March 10, 2023

Project Name: PEARL JUNIOR HIGH MULTIPURPOSE
Project No: 22-056
RE: Updated Civil and Structural drawings.

ADDENDUM NO. 01

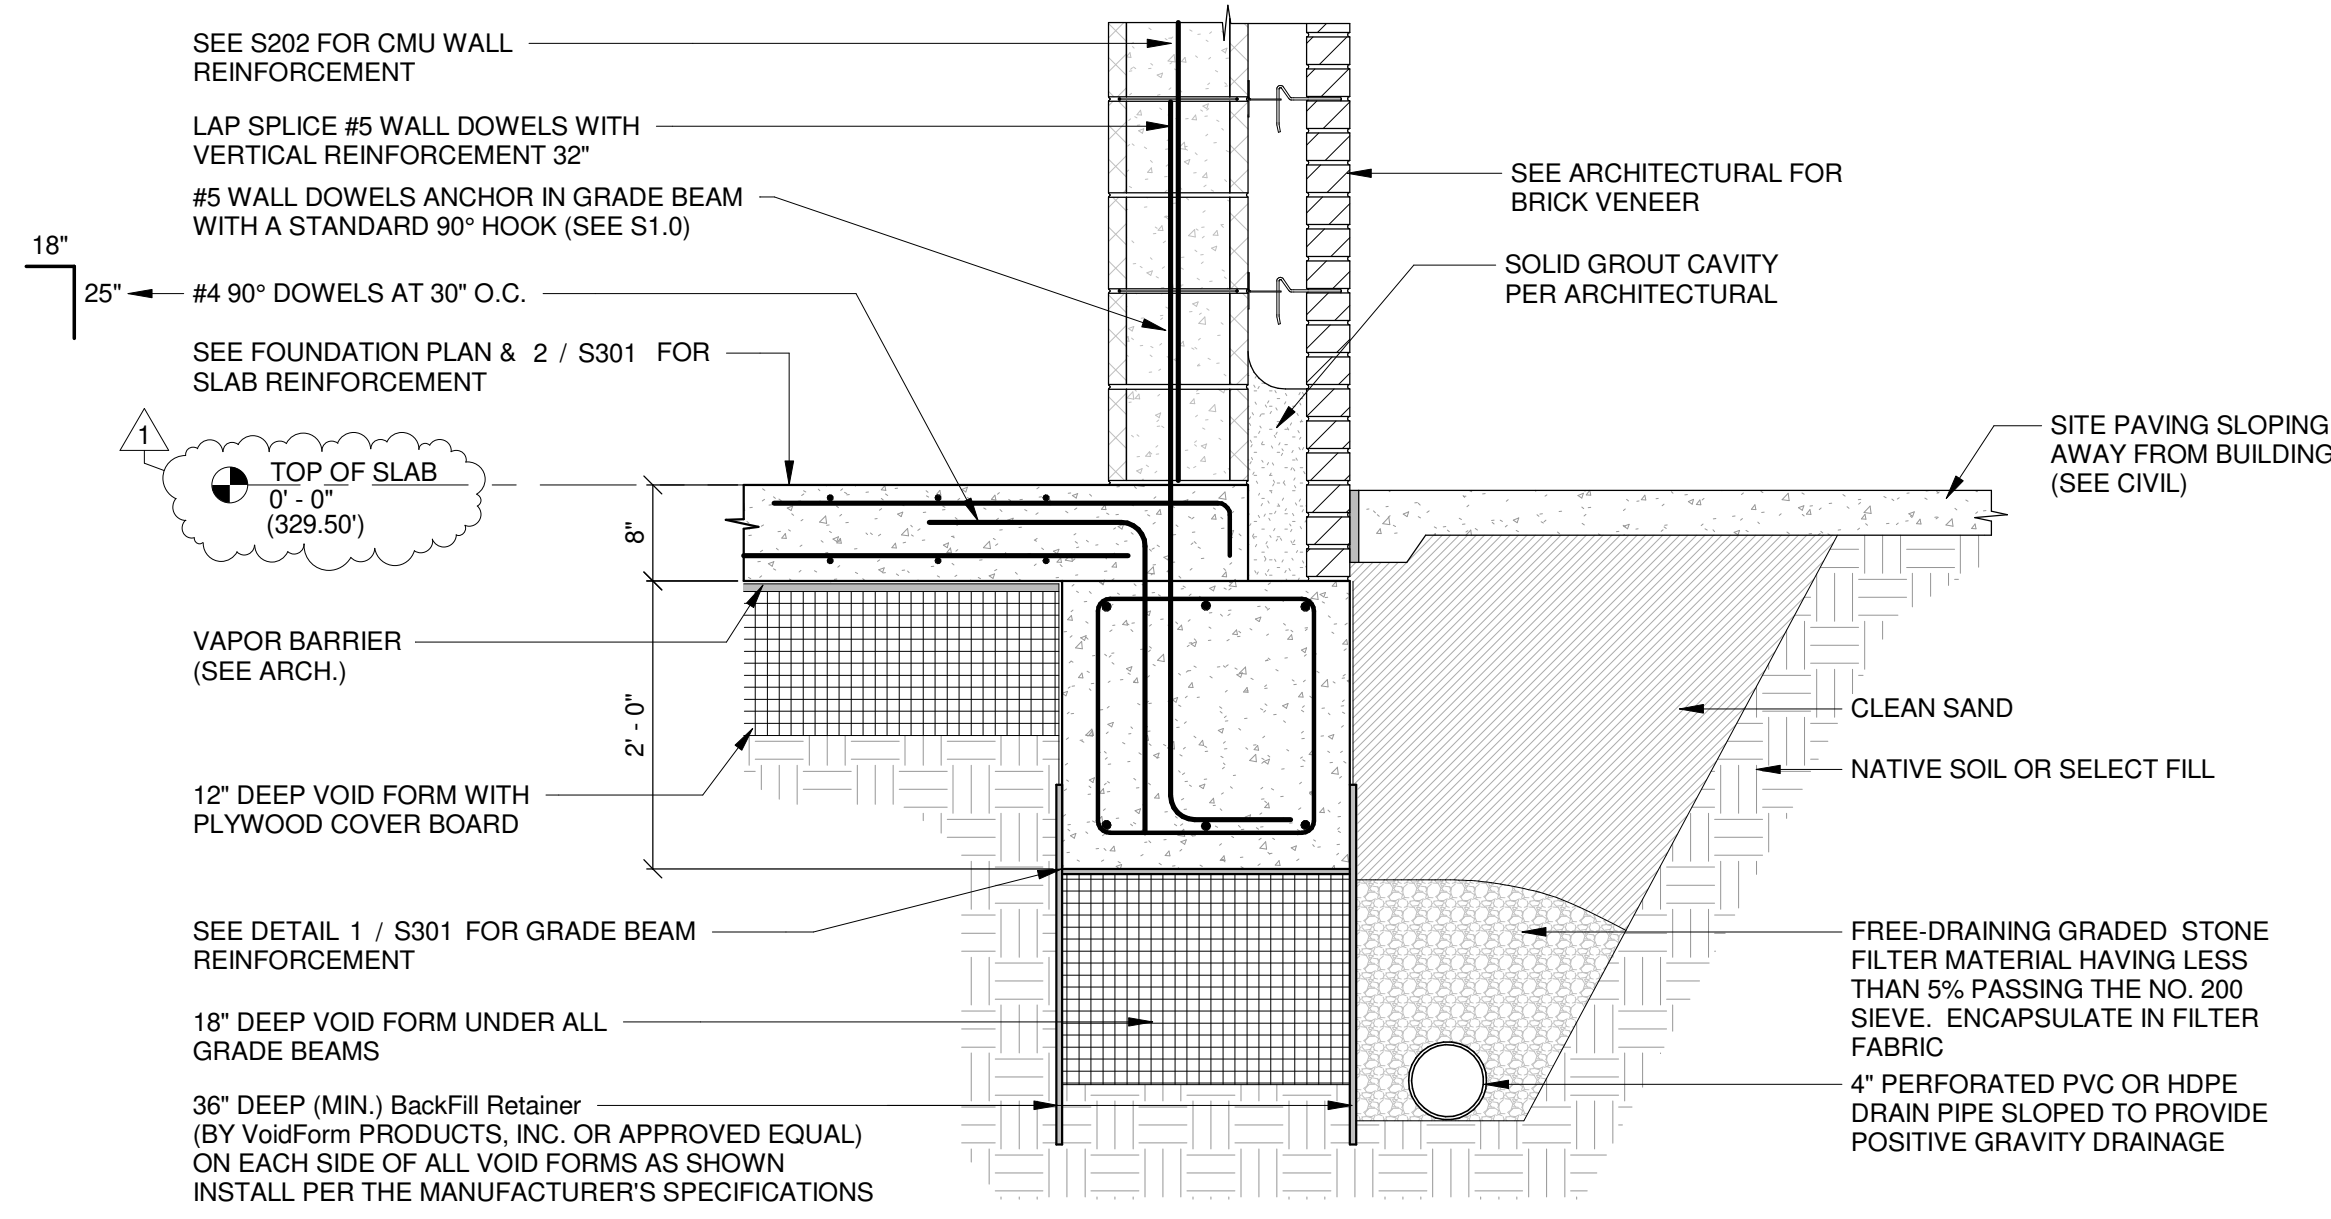
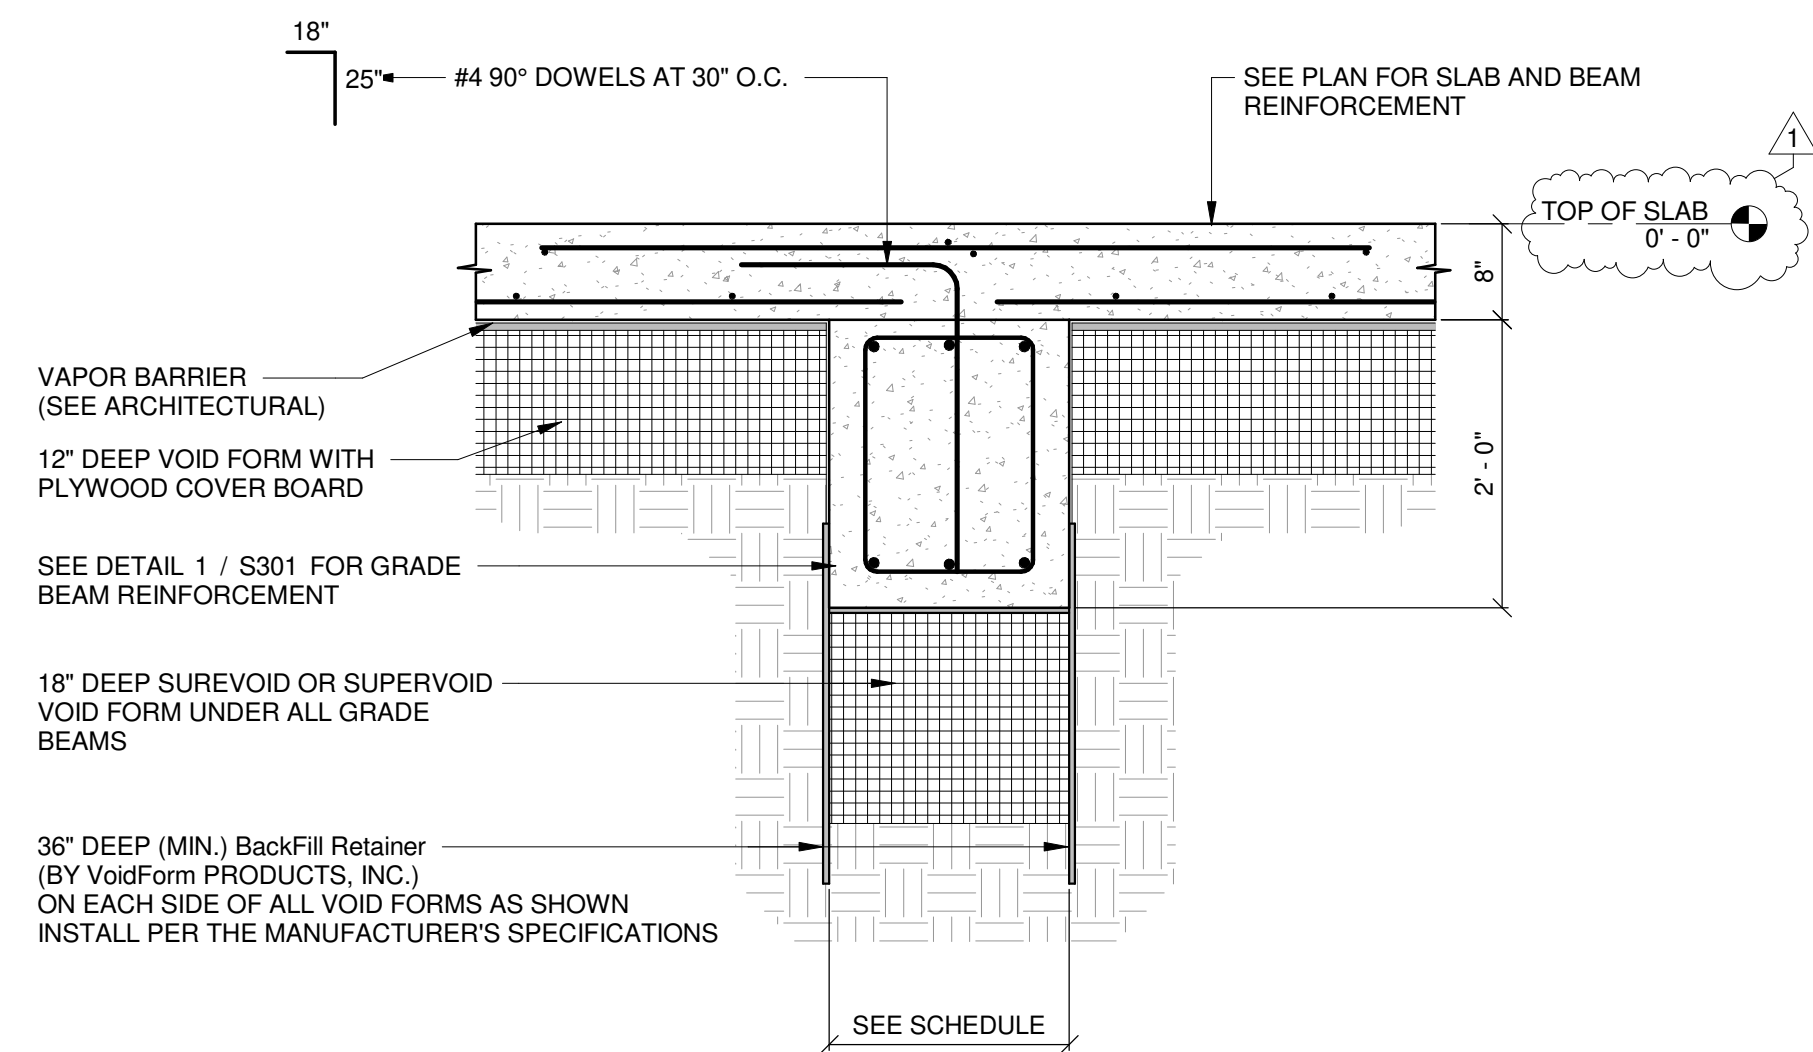
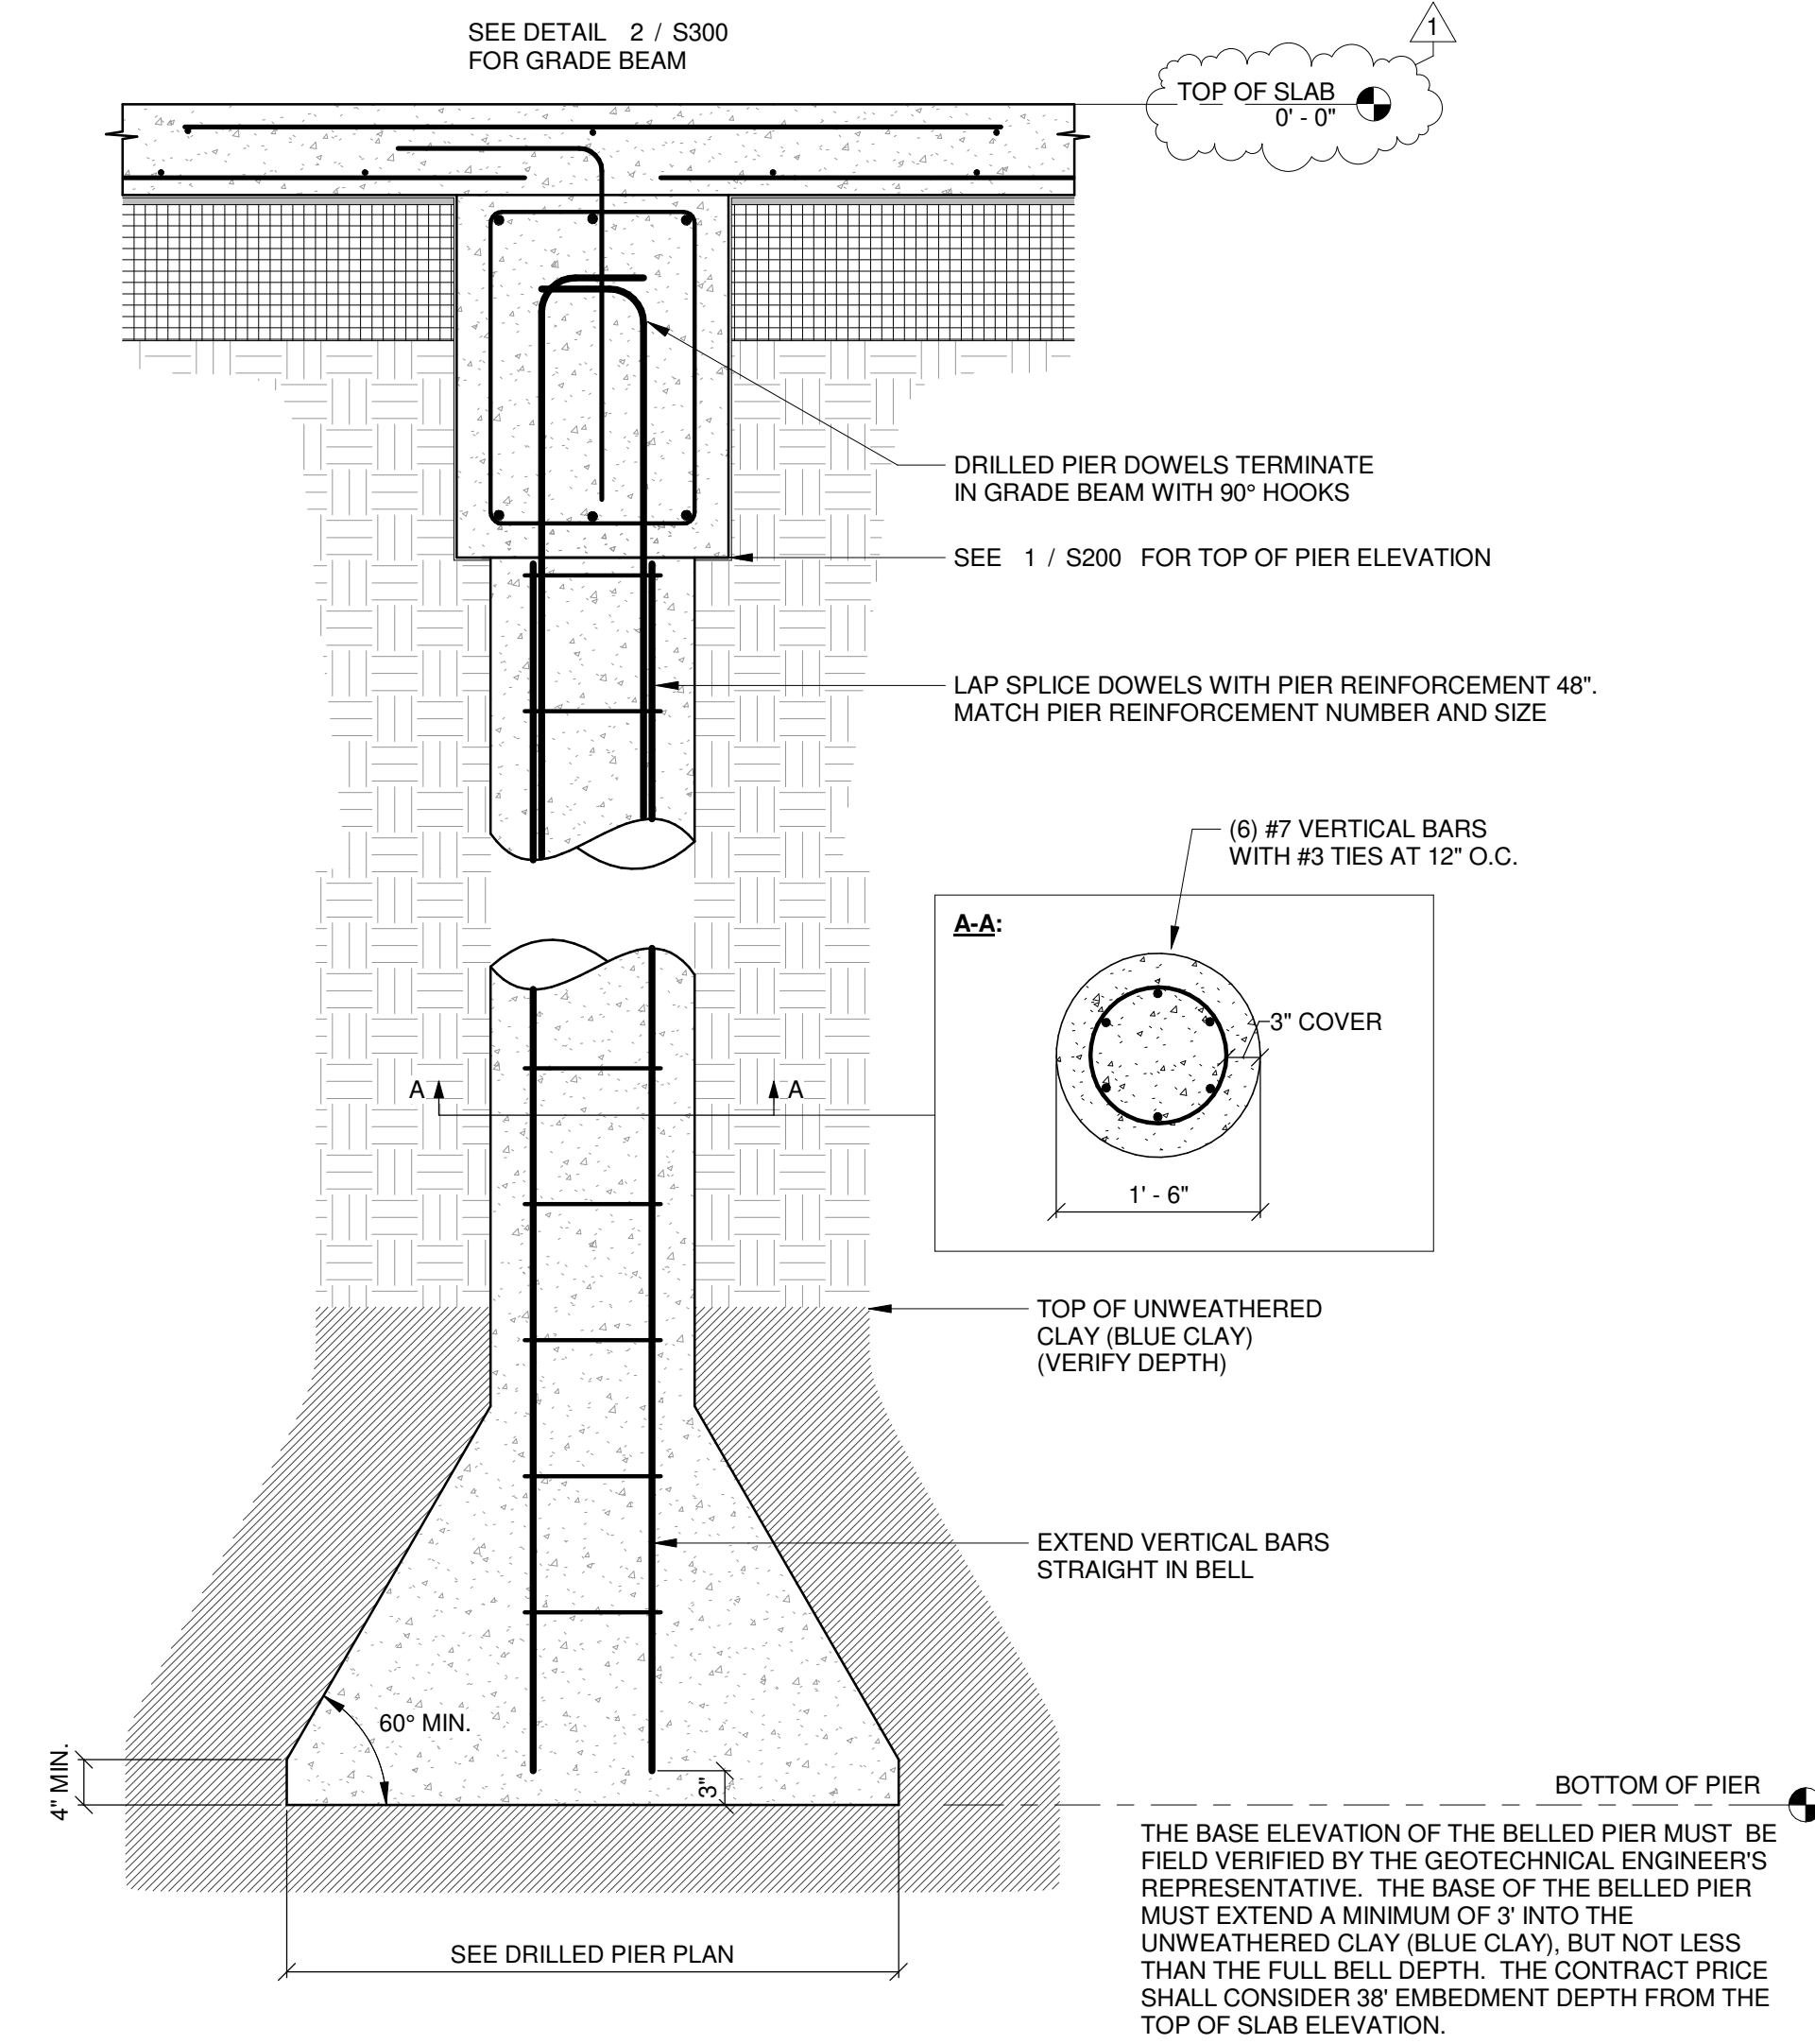
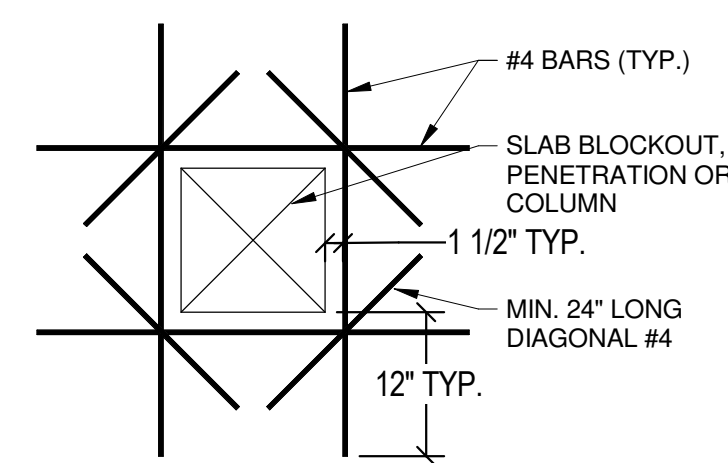
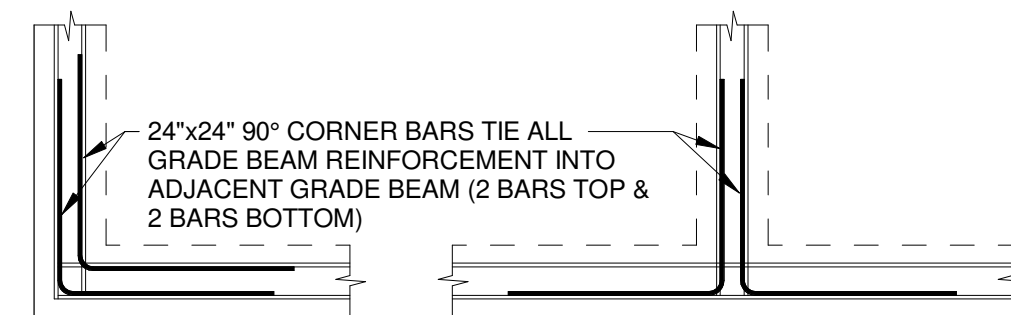
- S300 DETAILS
 - Modified top of slab level.
 - S301 DETAILS
 - Modified top of slab level.
